SUBJECT: REVISED SAFETY EVALUATION ON THE TENNESSEE VALLEY AUTHORITY (TVA)
SEQUOYAH NUCLEAR PERFORMANCE PLAN

REVISED PRELIMINARY SAFETY EVALUATION REPORT
ON TENNESSEE VALLEY AUTHORITY:
SEQUOYAH NUCLEAR PERFORMANCE PLAN
PART 1: PROGRAMMATIC EVALUATION

Figure 1. MSIV Solenoid EQ Test Chamber Temperature

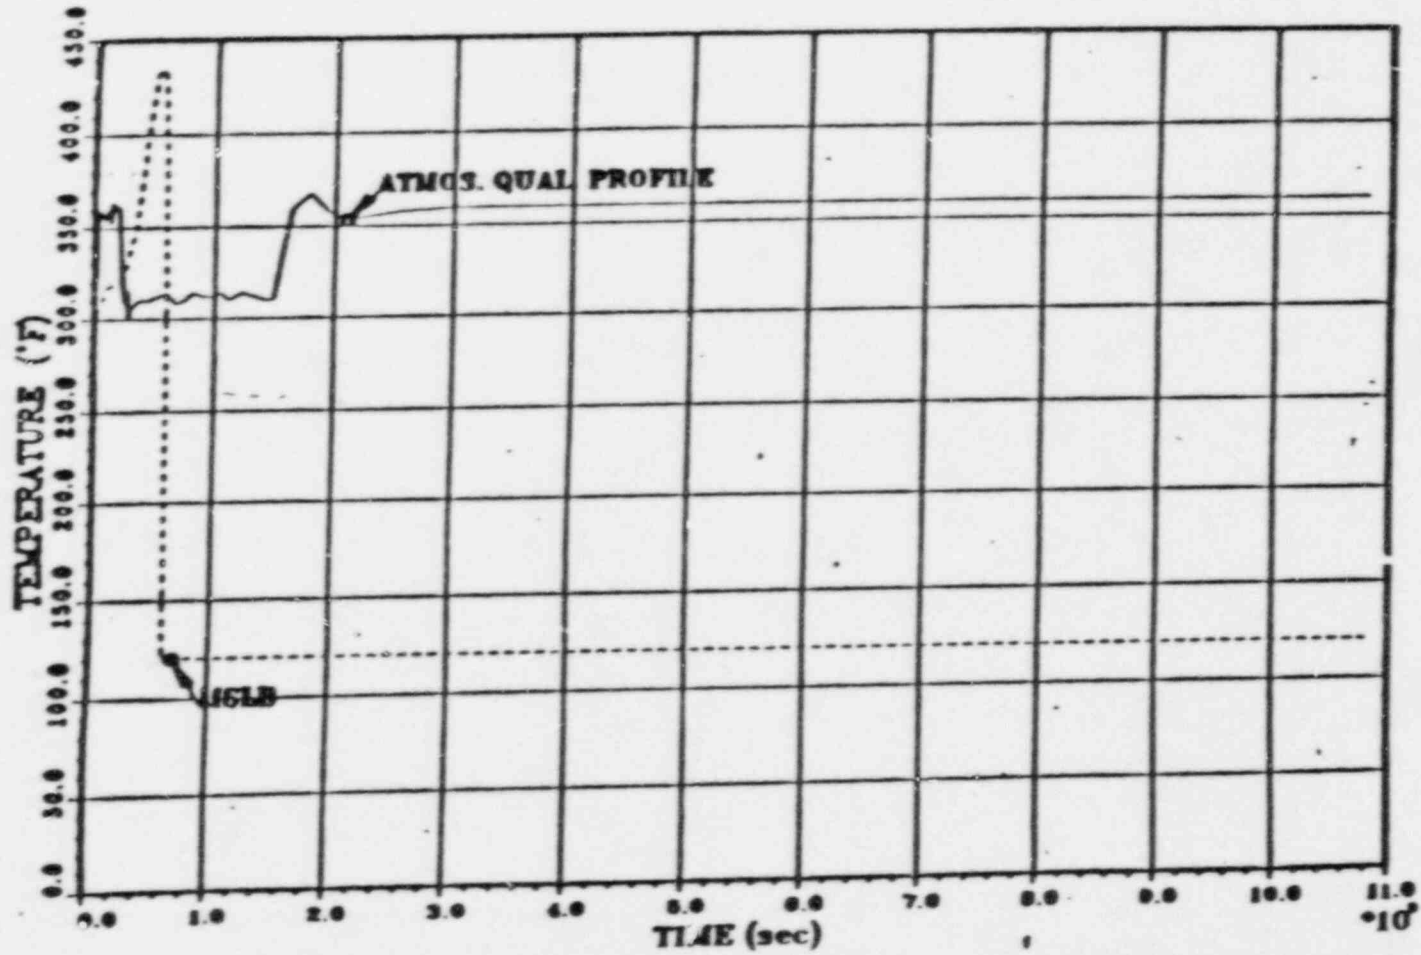
TVA also provided details of the guidelines used in constructing the heat transfer models. TVA's assumptions were made to conservatively increase the temperature predicted during a MSLB, while lowering the surface and internal temperatures resulting from analysis of EQ test chamber profiles. In this way, higher than expected surface and internal temperatures resulting from MSLBs are compared to lower than expected surface and internal temperatures derived from the qualification tests, thereby adding conservatism. The values of heat transfer coefficients used for the MSLB analyses were provided along with schematics of the models used. The Licensee concluded that qualification of the MSIV devices was established for each component by comparison of the calculated thermal response during a MSLB to the calculated response during qualification testing. The qualification for steam and moisture exposure is based wholly upon the existing qualification test results. The review of the existing qualification test results was not within the scope of this evaluation. The results of the existing qualification tests have been assumed to be acceptable during this evaluation. A sample of Licensee-supplied temperature profiles is included as Figures 1 through 3. Figure 1 represents the EQ temperature profile of a MSIV solenoid versus the MSLB temperature profile. Figure 2 is a plot of the calculated MSIV solenoid surface temperature during the MSLB. Figure 3 represents the calculated internal coil temperature during a MSLB as compared to the EQ test temperature.
